HICKORY CREEK ESTATES

RE: S/D 95-60 - Final Plat of Hickory Creek Addition

CASE NUMBER: S/D 95-60 HICKORY CREEK ESTATES ADDITION

S/D 95-60 - Final Plat of HICKORY CREEK ESTATES ADDITION

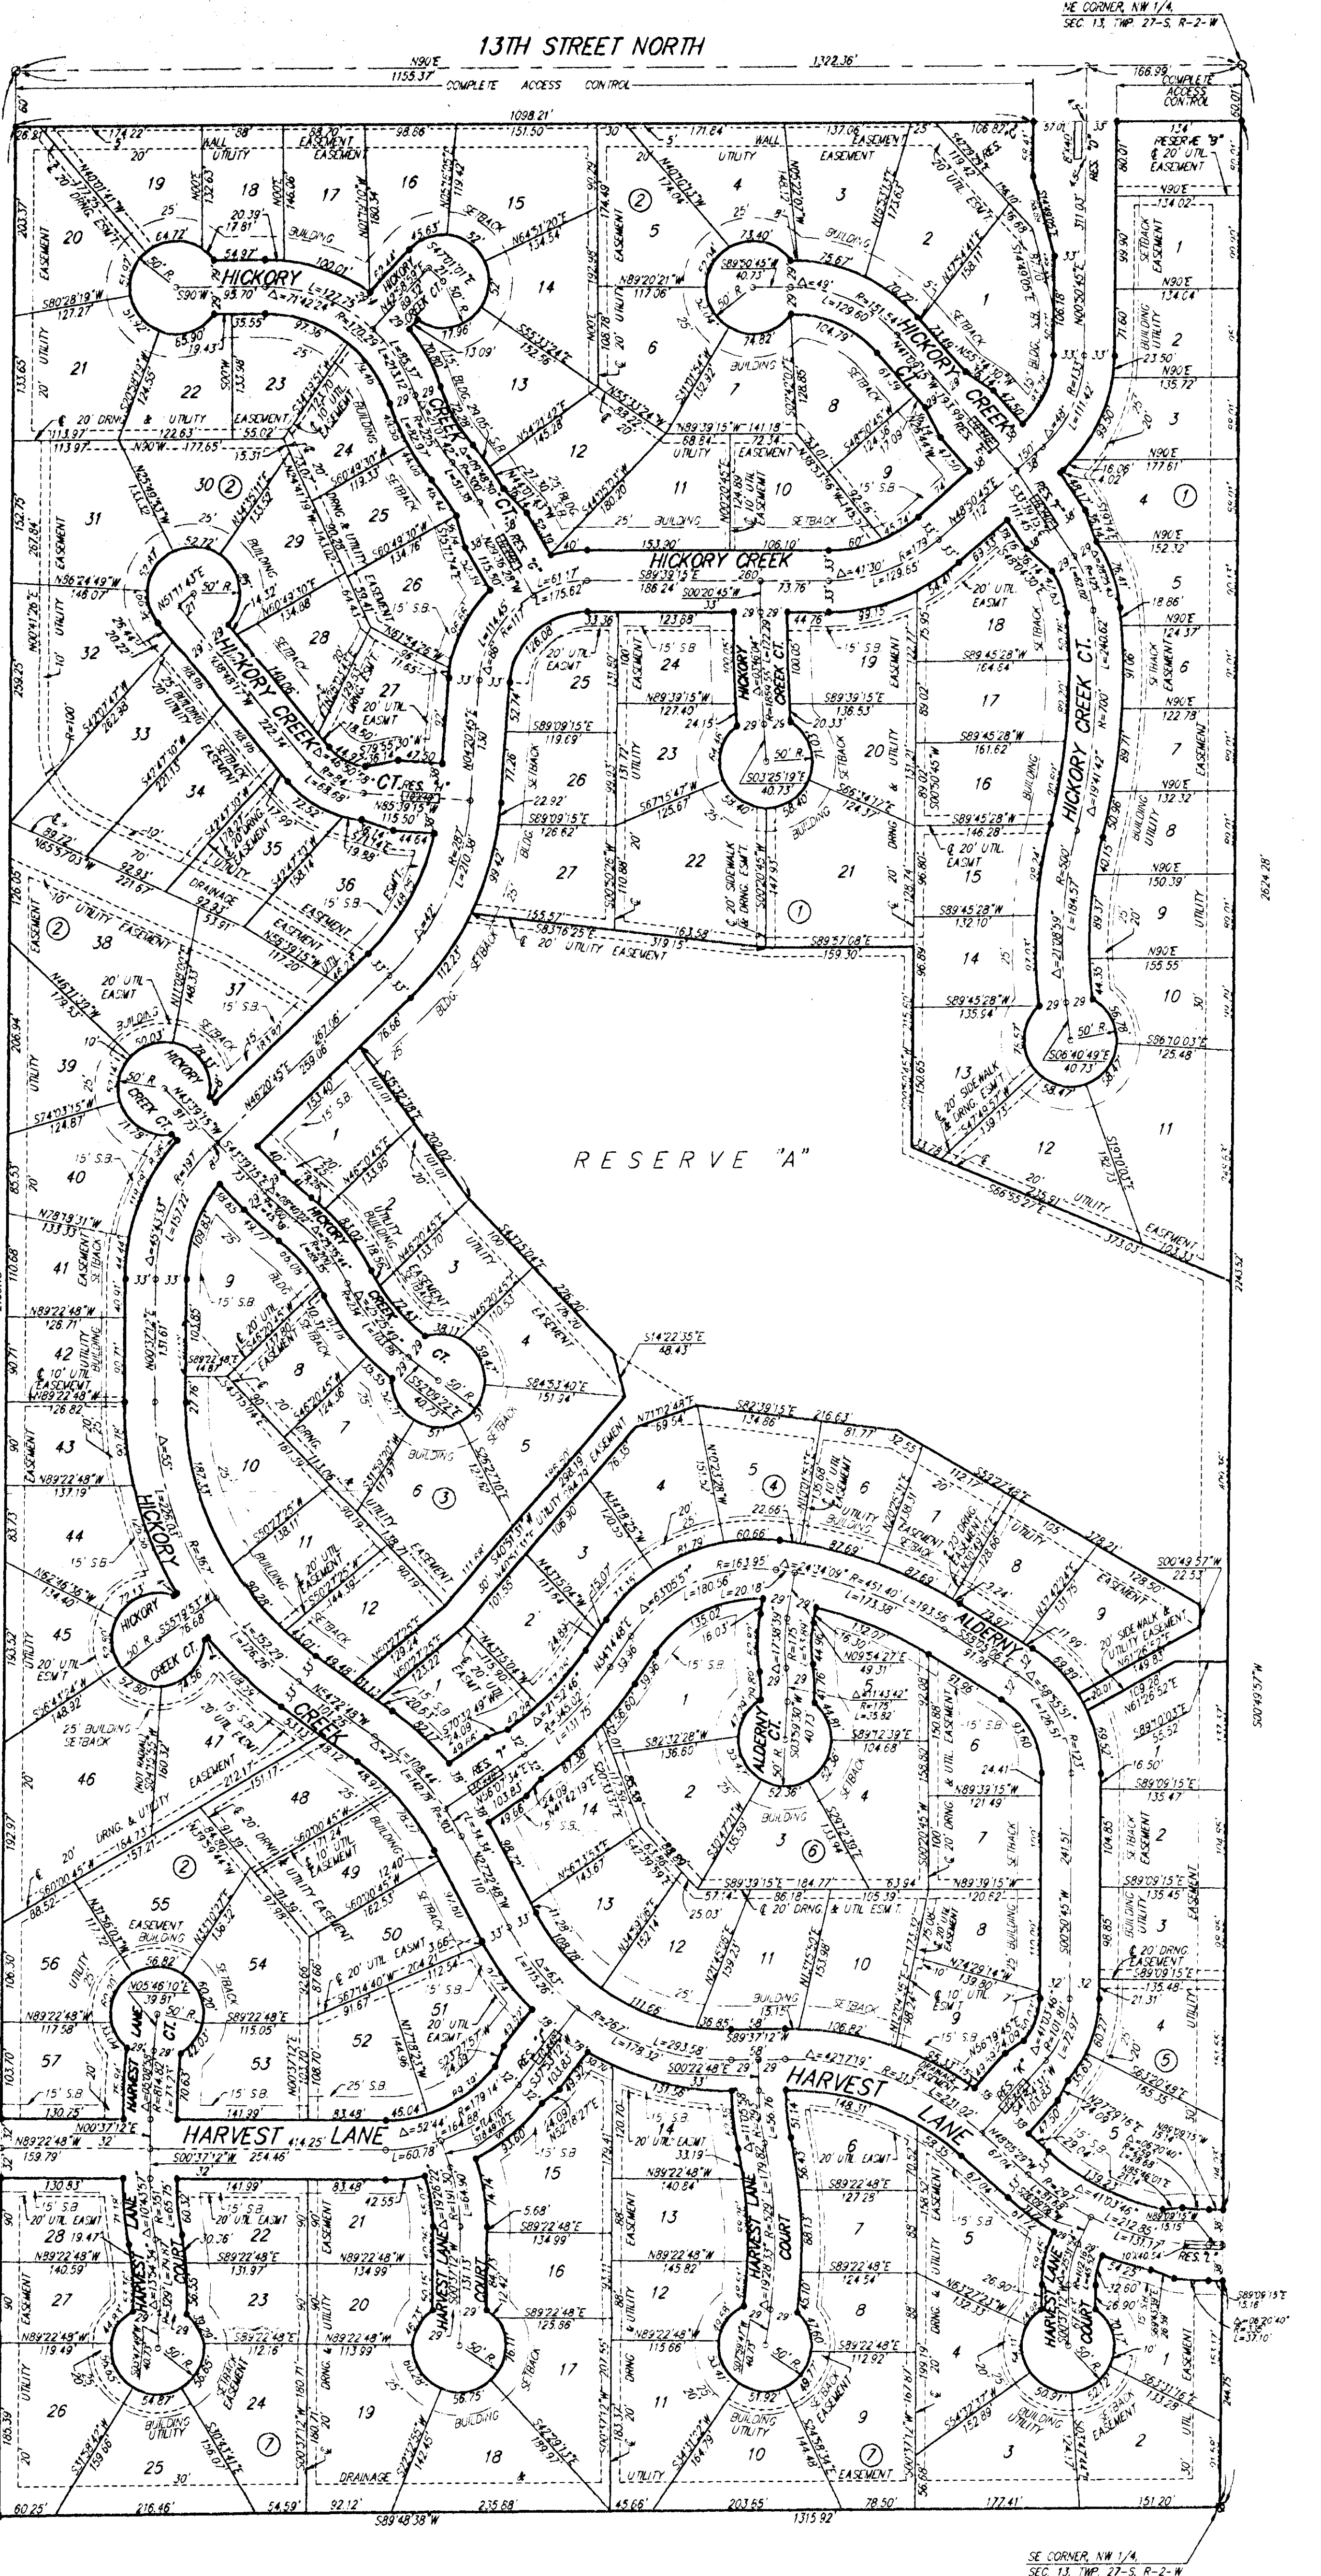
- A. Prior to this plat being forwarded to the Wichita City Council for approval, this site will need to have been annexed to Wichita. Upon annexation, this property will be zoned City "AA" one-family and will allow the lot sizes being platted.

- B. The applicant shall guarantee the extension of sanitary sewer to serve the lots being platted. The applicant shall also submit calculations needed to determine the capacity of a lift station needed to serve this site. If determined necessary by City Engineering, guarantees shall also be provided for any needed improvements to this lift station.

- C. The applicant shall guarantee the extension of City water to serve the lots being platted. This guarantee shall also provide for the extension of water across this site's frontage to 13th Street North.

- D. The applicant shall guarantee the paving of the proposed interior streets. This guarantee shall also provide for sidewalks. As a collector street, sidewalk is required along both sides of Hickory Creek/Azure. Sidewalks shall also be provided along one side of the section of Azure which extends westward into the abutting property.

While the need for sidewalks on both sides of a collector is typically considered essential because of concerns with safety, this plat's design involving a large Reserve, access easements or extensions of the Reserve and other streets paralleling the collector street suggests that one portion of the required collector sidewalks could be routed along an alternative path. If the applicant desires, an alternative sidewalk should be provided for consideration. That is, a sidewalk along one-side of the collector would still be required with the second section of sidewalk potentially following an alternate route; providing that

such alternate route basically supplements the collector's alignment.

- E. As requested by City Engineering, the applicant shall provide appropriate guarantees to participate in the paving of 13th Street North adjacent to this site.

- F. The applicant shall guarantee any drainage improvements required by the platting of this property. As requested by City Engineering, additional drainage information is needed before the drainage plan can be approved. Also any additional easements or widening of drainage easements determined necessary shall be provided for on the final plat tracing.

- G. The applicant shall guarantee construction of the storm sewers required by this plat.
- H. If improvements are guaranteed by petition, a notarized certificate listing the petitions shall be submitted to the Planning Department for recording.

- I. Provisions shall be made for ownership and maintenance of the proposed reserves. The applicant shall either form a lot owners' association prior to recording the plat or shall submit a covenant stating when the association will be formed, when the reserves will be deeded to the association and who is to own and maintain the reserves prior to the association taking over those responsibilities. Further, this covenant shall provide for the homeowners' association to maintain the "parking strip" area located between this plat's north line and the driving surface for 13th Street North.

- J. For those reserves being platted for drainage purposes, the required covenant which provides for ownership and maintenance of the reserves shall grant, to the City, the authority to maintain the drainage reserves in the event the owner(s) fail to do so. The covenant shall provide for the cost of such maintenance to be charged back to the owner(s) by a method similar to special assessments.

- K. The applicant shall submit a covenant which provides for four (4) off-street parking spaces per dwelling unit on each lot which abuts a 58-foot street. The covenant shall inventory the affected lots by lot and block number and shall state that the covenant runs with the land and is binding on future owners and assigns.

- L. The final plat tracing shall indicate on the face of the plat complete access control to 13th Street North from the adjacent lots and Reserves (D & C).

- M. It is recommended that the improvements (walks) for the pedestrian access easements be provided at the time of site development by the developer. Maintenance of the walks and easements should also be specified in this Addition's covenants.

- S. Perimeter closure computations shall be submitted with the final plat tracing. Section 5-101(c).
- T. Recording of the plat within 30 days after approval by the City Council.

- U. The final plat shall indicate the utility easements requested by K.G.& E. which are indicated on the enclosed "marked" copy of the plat.

- ~~B.~~ *Plat - SS - lift Sta - Main - etc provided*
The applicant shall guarantee the extension of sanitary sewer to serve the lots being platted. The applicant shall also submit calculations needed to determine the capacity of a lift station needed to serve this site. If determined necessary by City Engineering, guarantees shall also be provided for any needed improvements to this lift station.

- ~~E.~~ *has provided a formal agreement w/ C.E.*
As requested by City Engineering, the applicant shall provide appropriate guarantees to participate in the paving of 13th Street North adjacent to this site.

- ~~F.~~ *to check*
Scale
The applicant shall guarantee any drainage improvements required by the platting of this property. As requested by City Engineering, additional drainage information is needed before the drainage plan can be approved. Also any additional easements or widening of drainage easements determined necessary shall be provided for on the final plat tracing.
